INNER WEST COUNCIL

DEVELOPMENT ASSESSMENT REPORT

Application No.	DA201700214.01
Address	15 William Street, Marrickville
Proposal	Review request under Section 82A of the Environmental Planning and Assessment Act to review Determination No. 201700214, dated 17 July 2017, being a refusal of a development application to demolish part of the premises and carry out alterations and additions to a dwelling house including the construction of vehicular crossing and garage
Date of Lodgement	23 October 2017
Applicant	David D'ettore
Owner	Pasquale Barbalace
Number of Submissions	18
Value of works	\$99,000
Reason for determination at Planning Panel	A request made under Section 82A of the <i>Environmental Planning & Assessment Act 1979</i> and there is no substantial change in recommendation on the matters subject of the Review.
Main Issues	<ul style="list-style-type: none"> • Poor architectural outcome for the street • Adverse impacts to the architectural integrity of the period dwelling house • Adverse impacts to on-street car parking • Removal of a street tree

DATE OF ISSUE: 28/1/17 LOT: L DP: 101613 PAGE 9 OF 19
 RESIDENTIAL DESIGNER: BARBARA HOUSE PROPOSED NEW
 PROJECT: 15 WILLIAM STREET ADDITION AND
 MARKICKY V.L. 17/2/204 BASEMENT GARAGE
 SCALE: 1:100 @ 1/4

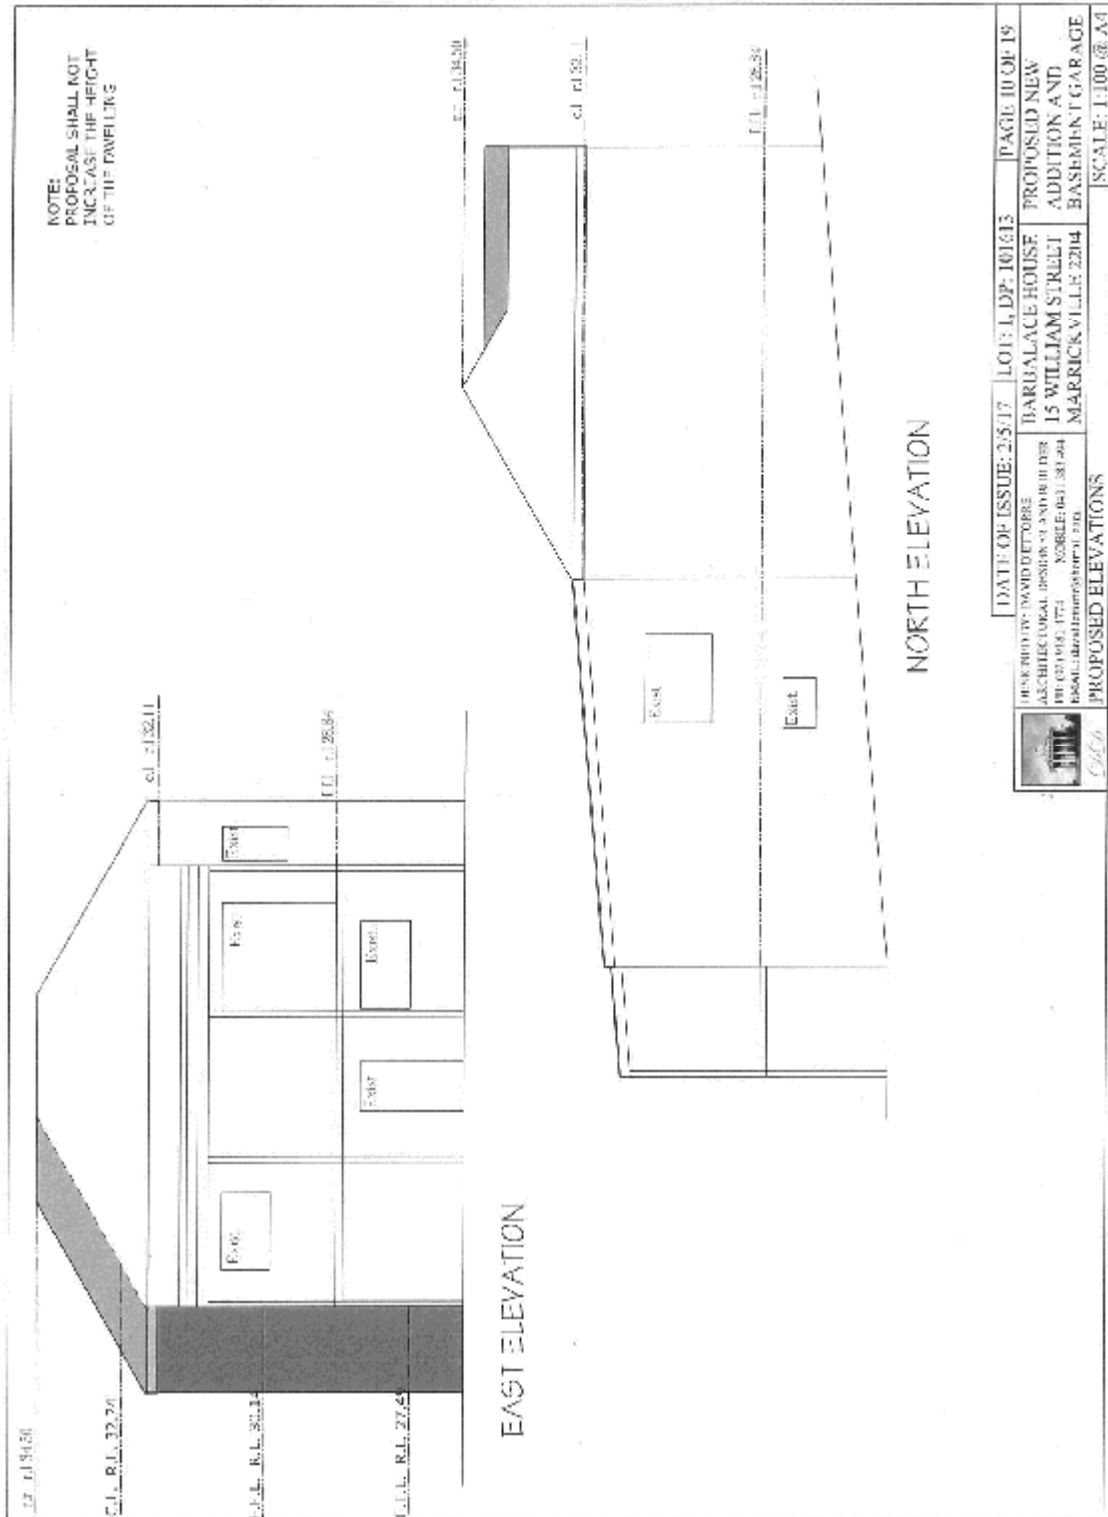
The proposal seeks to partially excavate and demolish the front façade of the dwelling house to accommodate a garage within an existing subfloor basement, create a side extension to enlarge bedrooms and provide an ensuite, relocate windows on the side (southern) elevation and brick up front windows. The above works will diminish the architectural presentation of the period dwelling façade by altering the original massing and architectural features of the dwelling house, reducing the size of window openings and creating structural elements (such as the garage door) that are not original to; and will not complement the main body of the dwelling façade when viewed from the street.

The above modifications will be obvious and noticeable and will create a poor design outcome and precedent for the street. The proposed sub-basement double garage will be a visually detractive feature for the locality and is inappropriate for the context of the street, which contains no double garages.

The development increases the overall massing of the roof to accommodate a side extension to the dwelling house to accommodate larger bedrooms and an ensuite. It appears that the development will cause additional shadow impacts to the northern (side) facing windows and private open spaces of 11 William Street and 18 Bright Street between 9.00am and 3.00pm on 21 June. However, the application was not accompanied by hourly and/or elevational shadow diagrams in the prescribed period to enable a complete and proper assessment of the shadow impacts caused by the proposed development.

The proposed development is considered to create a poor urban design outcome for the street in that diminishes the architectural presentation of the existing period building by altering the original massing and façade of the dwelling house, reducing the size of window openings and creating structural elements that are not original to; and will not complement the main body of the dwelling façade when viewed from the street.

The development extends the southern end of the dwelling house to accommodate larger bedrooms and an ensuite which will be highly visible to the street, thereby creating additional visual bulk to the front façade. This results in an inappropriate distortion to the original form, architectural expression and massing of the period dwelling house.

The application proposes to increase the existing single-width driveway to 6.2 metres which will require the removal of a Bottlebrush street tree fronting the site.

- The proposal will result in the loss of 1 "on street" car parking space;
- The minimum headroom of 2.2m as required by AS2890.1:2004 has not been achieved;
- The cross section provided (Page 13 of 19) has insufficient detail to assess if a B85 vehicle will scrape the footpath when accessing the site. The vehicular crossing is required to satisfy the ground clearance template for a B85 vehicle (Figure C1-Australian Standard AS2890.1-2004). A cross section through both sides of the driveway and adjacent footpath (1 in 20 scale) is required for review and has not been provided; and
- The proposed vehicular crossing will result in the loss of a street tree.

Issue: The plans are inaccurate; with some discrepancies on the plans including an incorrect portrayal of 'proposed' works which are already completed on the dwelling house, such as a 'new' window on the south elevation, and incorrect floor levels.

Council's Tree Management Officer has recommended that the existing driveway be maintained at its existing width and the street tree retained.
